<b>AMENDMENT OF SOLICITATION/MODIFICATION OF CONTRACT</b>				I. CONTRACT ID CODE J	PAGE OF PAGES 1   3
2. AMENDMENT/MODIFICATION NO. 0001	3. EFFECTIVE DATE 17-Sep-2004	4. REQUISITION/PURCHASE REQ. NO. W34GM1-4225-0001	5. PROJECT NO.(If applicable) FE21139-4J

14. DESCRIPTION OF AMENDMENT/MODIFICATION (Organized by UCF section headings, including solicitation/contract subject matter where feasible.) Solicitation, W91248-04-Q-0086, Replace Fire Alarm Panel in Building 6944, Fort Campbell, Kentucky is amended as follows:  <p style="text-align: center;">SEE ATTACHED SHEET</p>					
Except as provided herein, all terms and conditions of the document referenced in Item 9A or 10A, as heretofore changed, remains unchanged and in full force and effect.					
15A. NAME AND TITLE OF SIGNER (Type or print)			16A. NAME AND TITLE OF CONTRACTING OFFICER (Type or print)		
			TEL: _____ EMAIL: _____		
15B. CONTRACTOR/OFFEROR  _____ (Signature of person authorized to sign)	15C. DATE SIGNED	16B. UNITED STATES OF AMERICA  BY _____ (Signature of Contracting Officer)		16C. DATE SIGNED 17-Sep-2004

Solicitation, W91248-04-Q-0086 to Replace Fire Alarm Panel in Building 6944, Fort Campbell, Kentucky is amend

FACILITY NUMBER  
P6944-2A

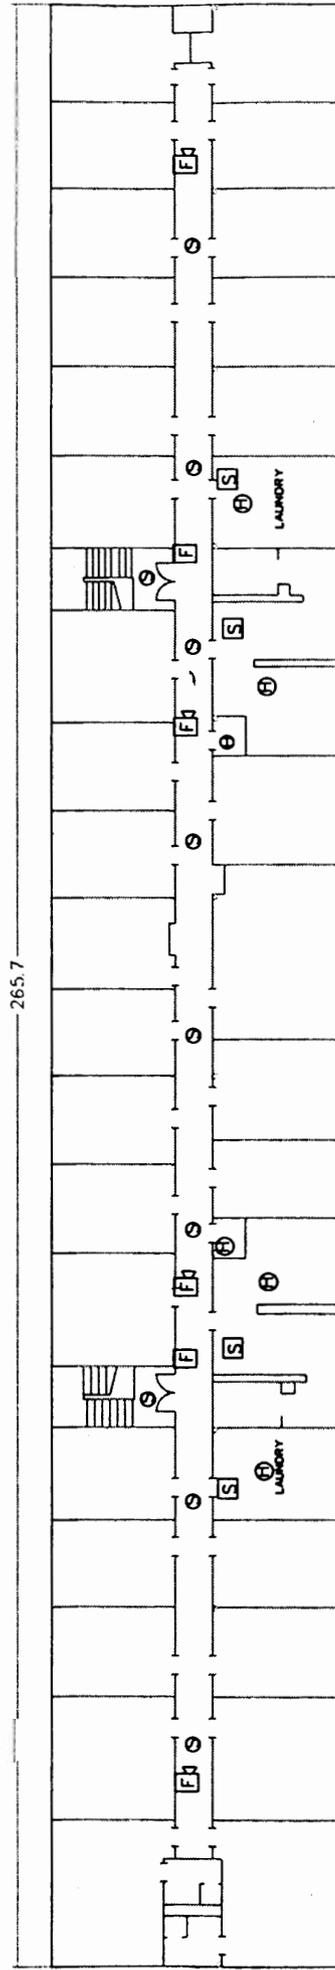
1. Hall is approximately 244 feet.
2. Drawings are not accurate; Contractor shall verify correct location for devices prior to installation.

P6944-1A

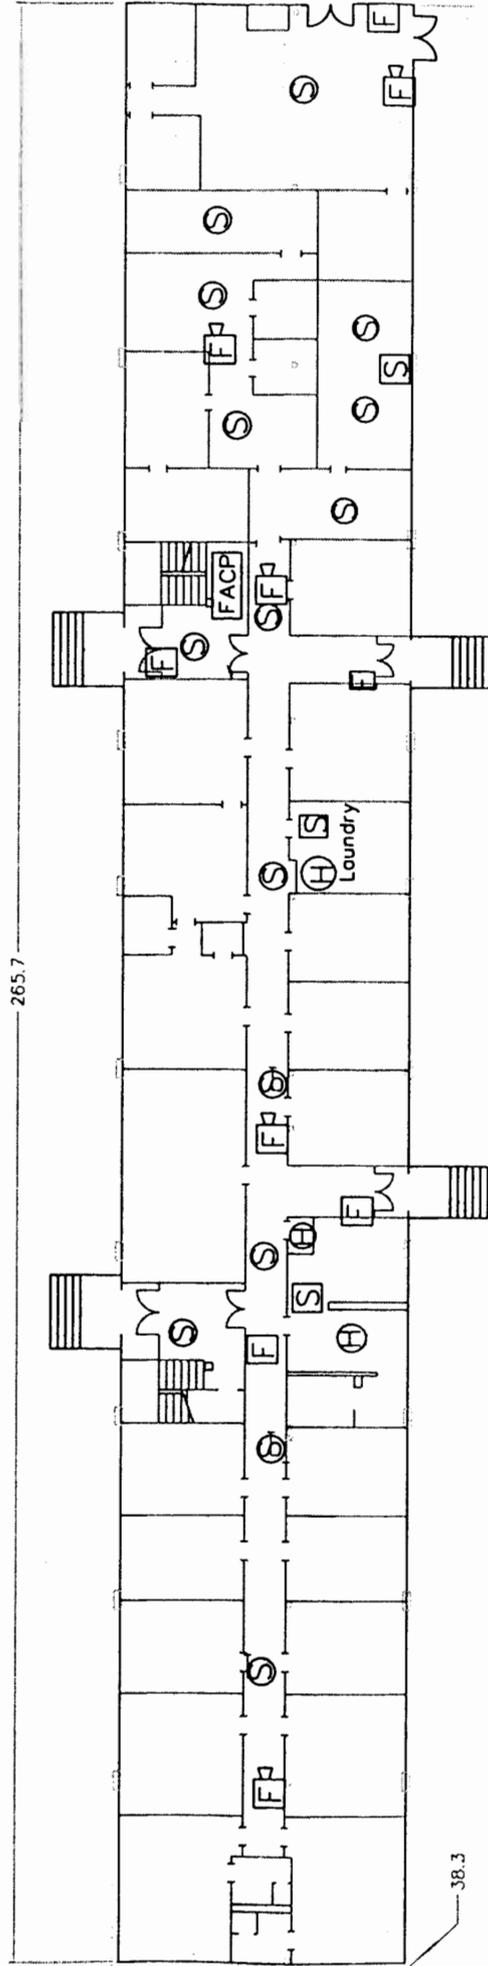
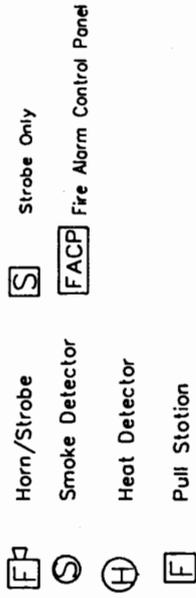
- Hall is approximately 190 feet.
- Drawings are not accurate; Contractor shall verify correct location for devices prior to installation.

FACILITY NUMBER  
P6944-1WA

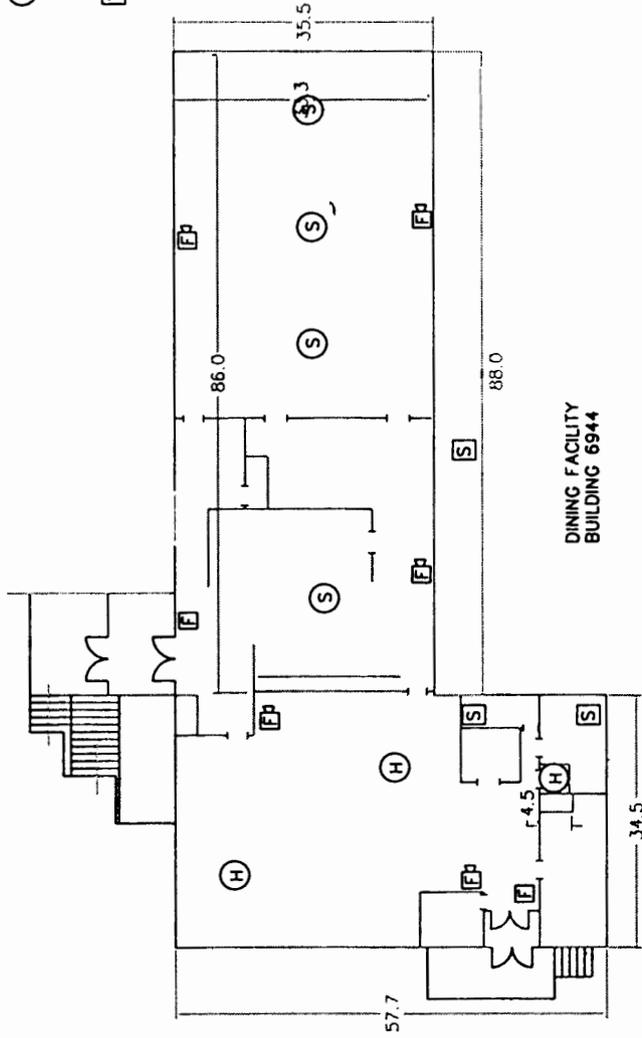
1. Drawing is intended as a guide only
2. Exterior Strobe Shall be Weatherlight

1. Drawings are not correct. Contractor shall verify correct location for devices prior to installation.

6944

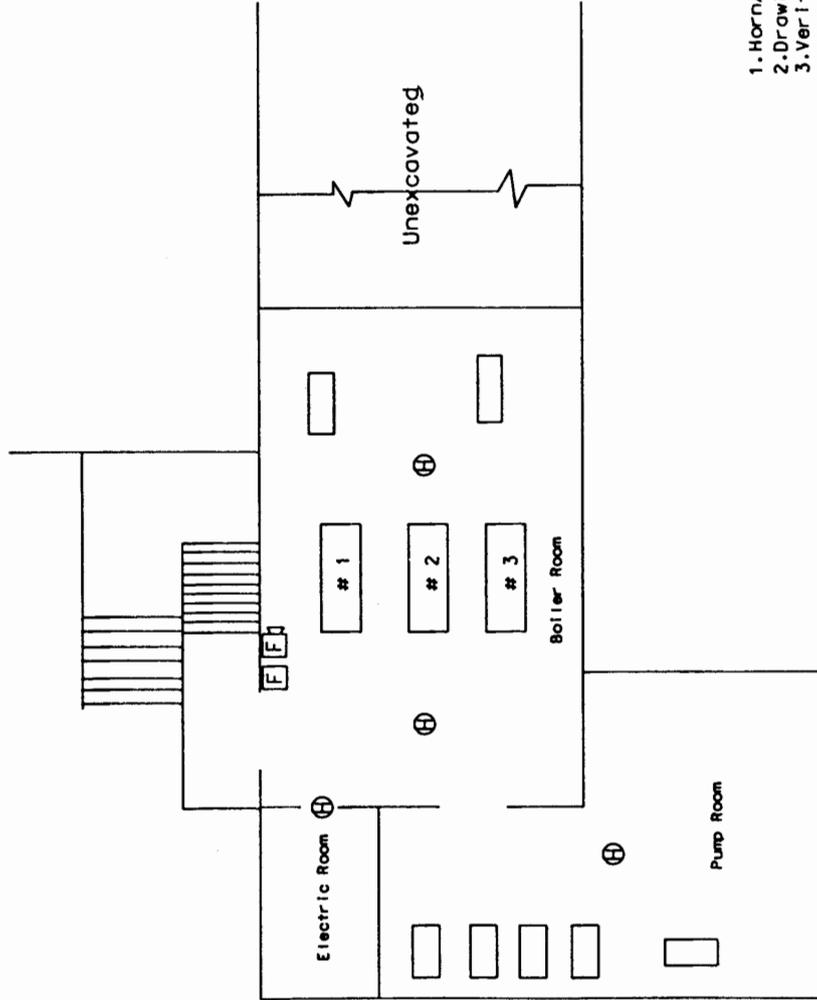
1. Horn/Strrobe and Pull Station shall be Weathertight
2. Drawing is intended for a guide only
3. Verify location of devices prior to installation.
